RECOMMENDATION NUMBER: 382

TITLE: SYSTEM FOR RECOVERY OF WASTE HOT
WATER HEAT ENERGY

Final Technical Review

FINAL TECHNICAL REVIEW
System for Recovering Waste Heat
ORNL No. 009925

HEAT EXCHANGER SUBASSEMBLY DWG A-1

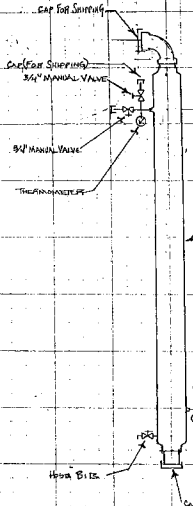
The governing health authorities may require a double-walled separation between the potable water and waste water. Approval from health authorities must be acquired before finalizing the design and construction of the prototype heat exchangers. Mr. Pravda has suggested a double-walled HX design which satisfies this requirement. This HX design appears to be fairly simple and could be mass produced with current level of technology.

Before this product is marketed, approval must be obtained from local health authorities. It appears a double-wall separation will be required between the potable water and the waste water. Mr. Pravda has proposed a HX design with double-wall separation.

4. A design development and test program is needed for the proposed EX.
 - a. A practical EX system should be engineered and design drawings prepared, keeping in view the retrofit application for a majority of homes. Approval of the EX design from appropriate health authorities should be obtained before proceeding with fabrications. The appropriate EX material should be selected based on various factors involved, such as initial cost, ease of fabrication and installation, optimum energy saved and shorter payback.
